Corby Estate / Strathmore Hall

Window Rehab. HPC 7/10/96

Re: Easement Committee Review
Strathmore Hall
Montgomery County

Address: 10701 Rockville Pike	Meeting Date: 7/10/96
Resource: <u>Master Plan</u> Site #30/12, Corby Estate/Strathmore Hall	HAWP: Alterations
Case Number: 30/12-96A <i>REVISION</i>	Tax Credit: Not Applicable
Public Notice: 6/26/96	Report Date: 6/03/96
Applicant: Mary K. Donohoe	Staff: Patricia Parker
PROPOSAL: Remove and replace 10 windows and 3 doors; Window/door rehabilitation in remaining openings	RECOMMEND: Approve w/condition

REPLACEMENT SASH DETAILS

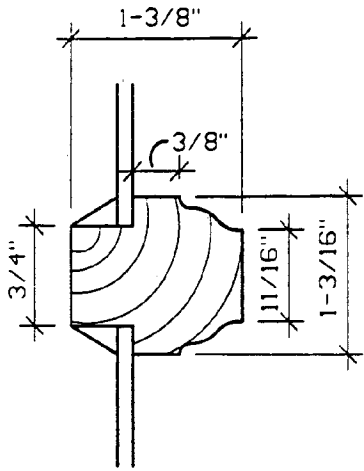
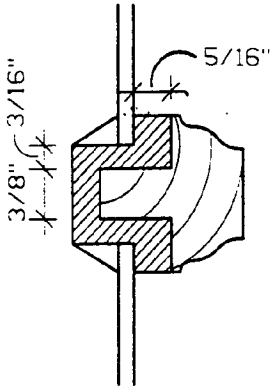
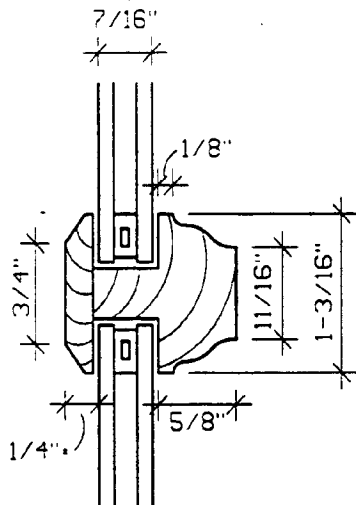
Modifications to Muntin
(hatched area will
be removed)

Re-Configured Muntin Bar
with Insulated Glazing

Photo #11: Interior detail view of meeting rail with tailpieces. Window No. 205.

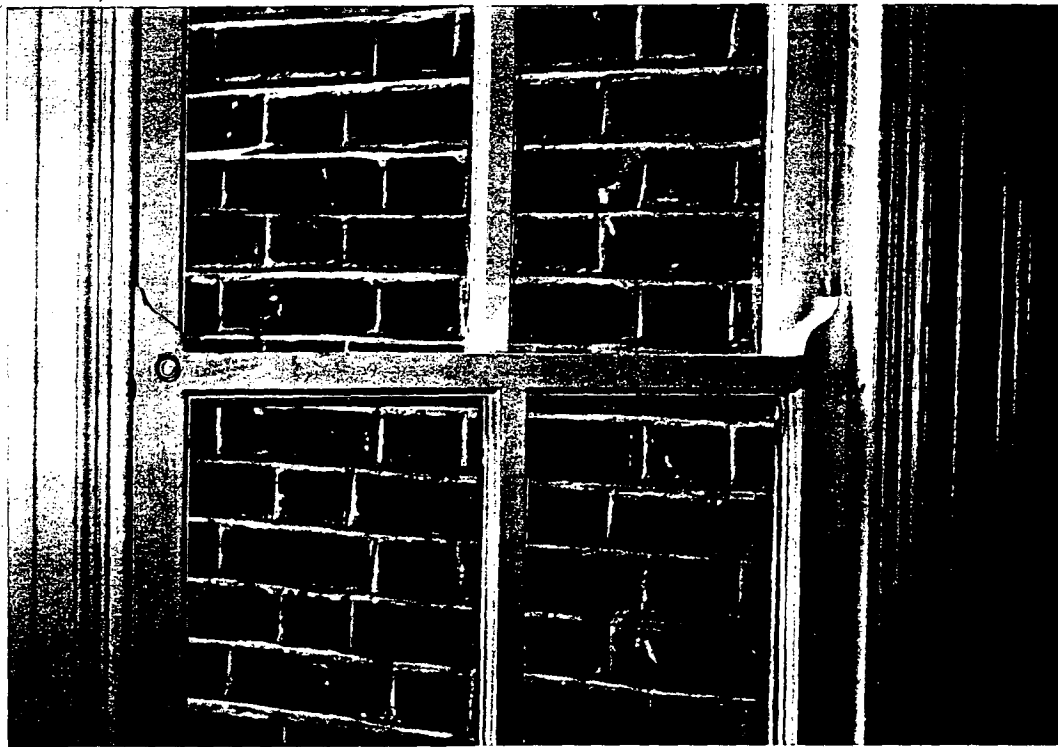
- #4: Exterior view of sash at Library.
- #5: Exterior view of sash at Gallery (Rm. 110).
- #6: Detail view of jamb width.
- #10: Exterior view of sash (upper level).
- #11: Interior detail view of meeting rail with tailpieces.

Comment: Thermal performance of these sash is poor due to the lack of storm sash or insulated glass. Air infiltration rates are high due to the lack of complete perimeter weather-stripping.

Work: Incorporate insulated glazing units into the existing true-divided-light windows. Existing muntins, rails and stiles will be modified to accept the thickness of the insulated glazing units. All interior profiles will be retained. New exterior wood stops will consist of Philippine Mahogany which will be beveled, creating a "putty line" similar to the existing window construction. Upper sash will be fixed in place. Repaint exterior and interior of sash to match existing.

Photo #15: Exterior view of second floor French door No.s 259A. These doors will be replaced with true divided lite French doors.

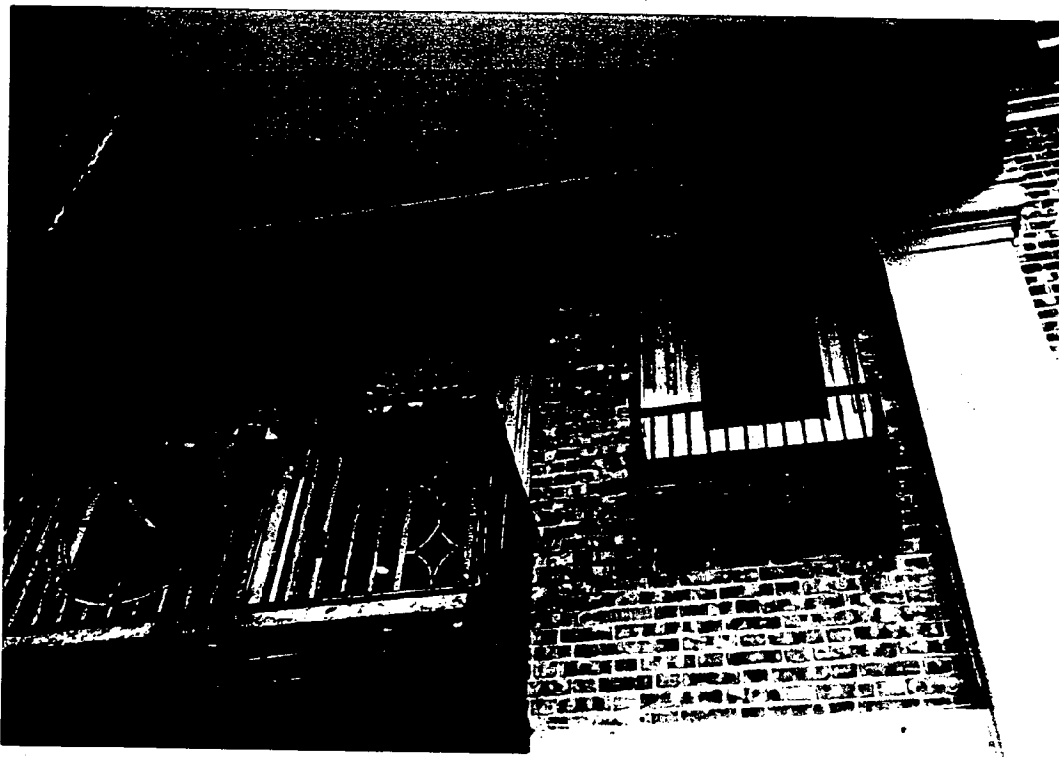
- #14: Exterior view of south entrance doors.
- #15: Exterior view of second floor French doors.
- #3: Detail of base of Music Room French doors.

Comment: Thermal performance of these doors is poor due to the lack of storm doors or insulated glass. Air infiltration rates are high due to the lack of complete perimeter weather-stripping.

Work: Provide new, double insulated, tempered glass wood French door replacements at entrances. Stile, rail and muntin widths and profiles to replicate appearance of existing doors. Door thickness to be 1-3/4". Provide panic hardware at exit doorways. Retain existing door frames. Paint exterior and interior of new doors to match existing. Provide true divided-lite French doors at second floor portico. Restore existing French doors at Music Room and replace glazing with tempered glass (muntin bars are too narrow to accept insulated glazing units).
